Tauranga City Council
21 Devonport Road
Tauranga 3143
New Zealand

BC330131 Request for Further Information #3 - Category 1 Geo-Professional Review

Awaiti Project Geotechnical Investigation and Desktop Summary Report

Mauao Viewing Platform	Mauao viewing platform.gsz Existing static	Job Number: 4280807	Date: 13/04/2023
			Scale: 1:50	4280807-GA-K001

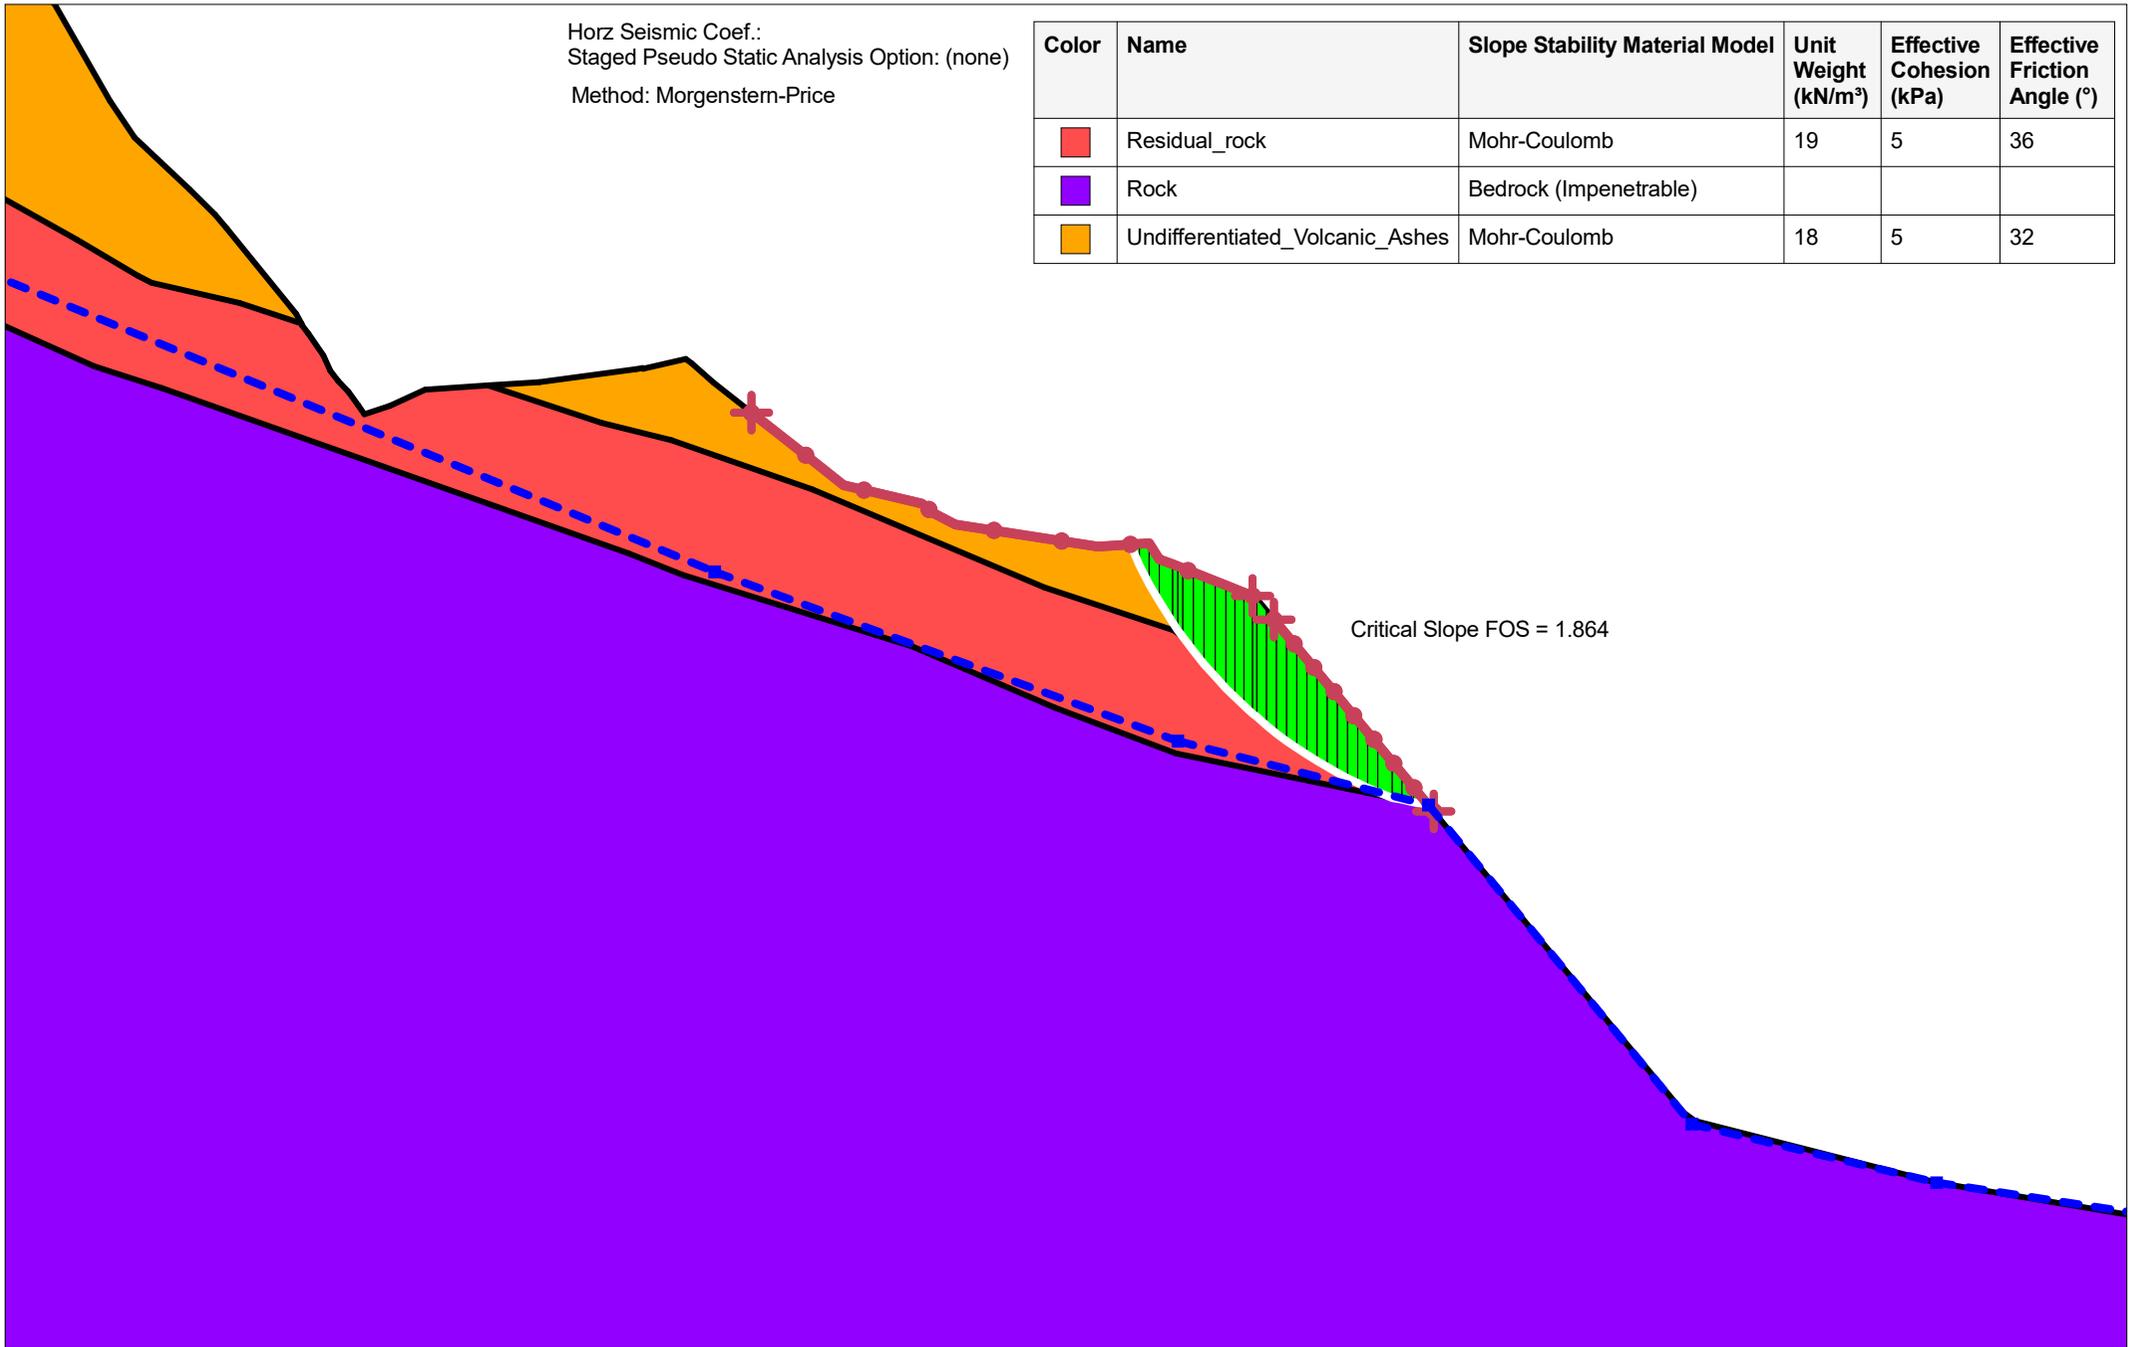
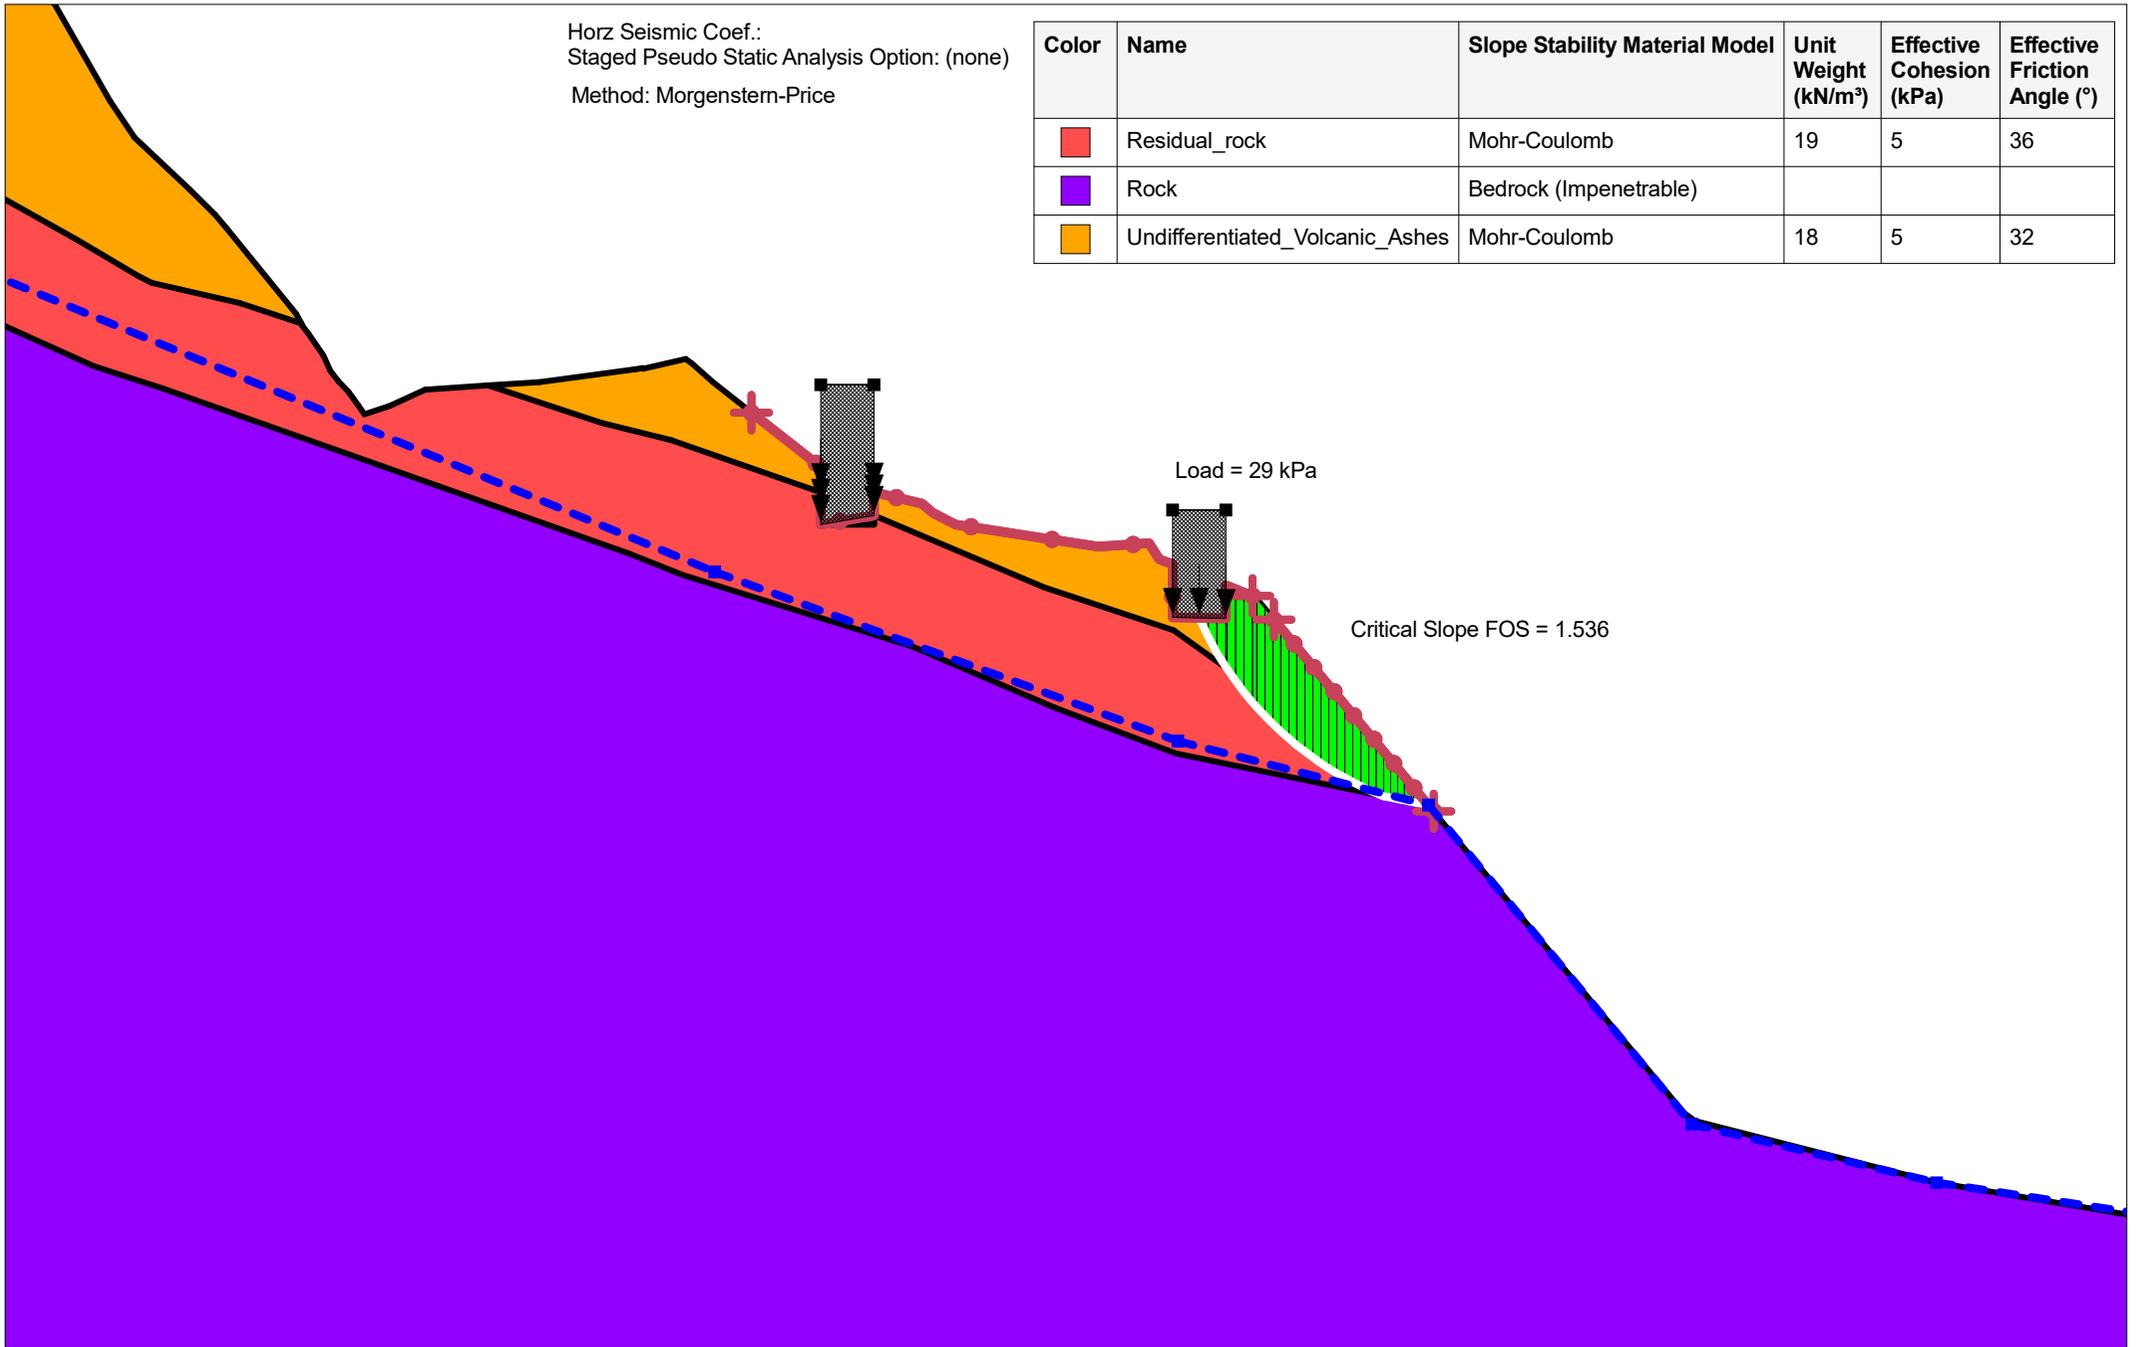
Question 1: Provide a review of the Beca geotechnical report dated 30/9/2022 from a Category 1 Geo-Professional and include a S72 assessment in respect to land stability.

We carried out analyses for the existing conditions and with the proposed structure. The results of the analyses are summarised in Table 1 below. In all cases the slope stability meets the minimum requirements of TCC IDC DS-10.

Case	Minimum Factor of Safety required	Existing	Proposed	Requirements met?
Static	1.5	1.87	1.54	Y
Extreme groundwater level	1.2	1.47	1.22	Y
Seismic	1.0	1.27	1.26	Y
